Planning Application Ref: AW/139/20/T

Location: 5 Heston Grove, Aldwick, PO21 4LL

Description of works: Fell 1No. English oak (T1585) stump to be left at 2.5-3m & Reduce crown of 1No. field maple (T1592) by to height 10.5-12m and spread 4.5-6m

Figure 2 Positions of final cuts

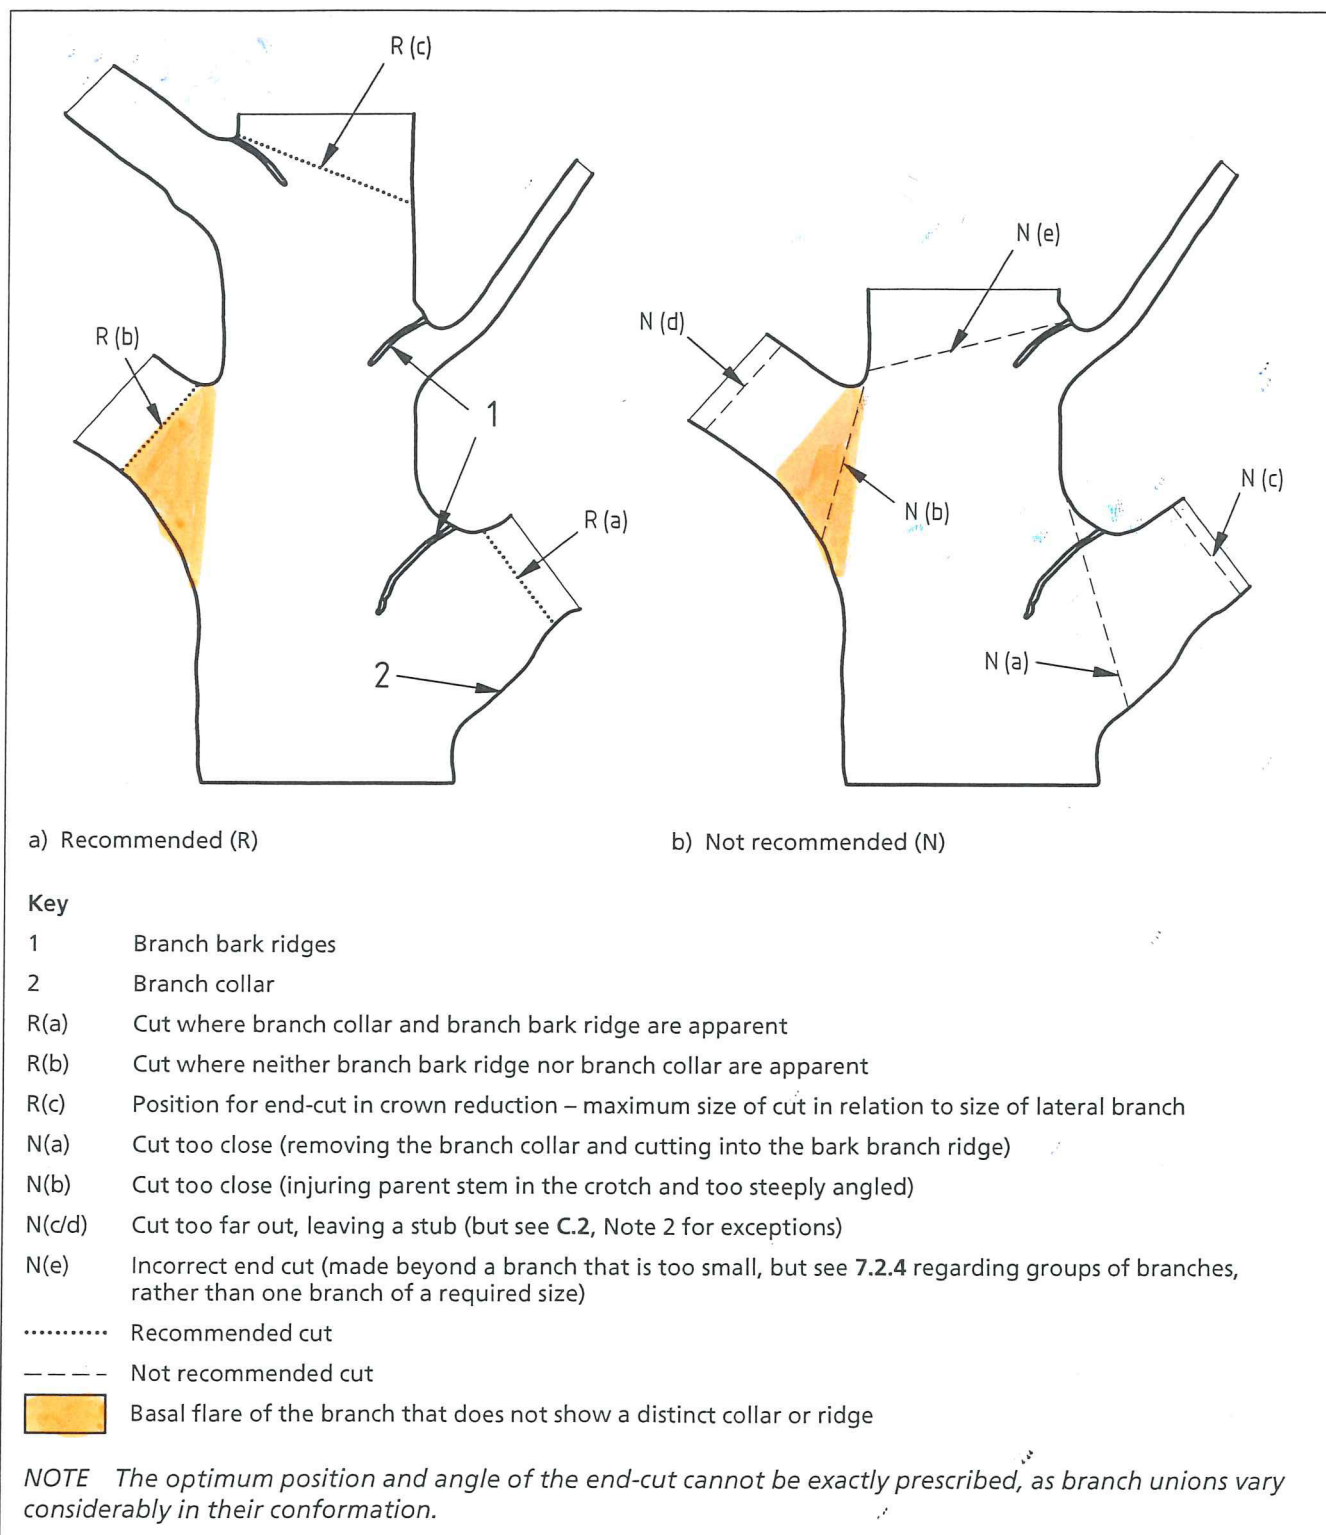
Part a) Where whole branches are to be removed and final cuts made close to the trunk or branch union they are to be made as shown in Figure 2 of BS3998:2010
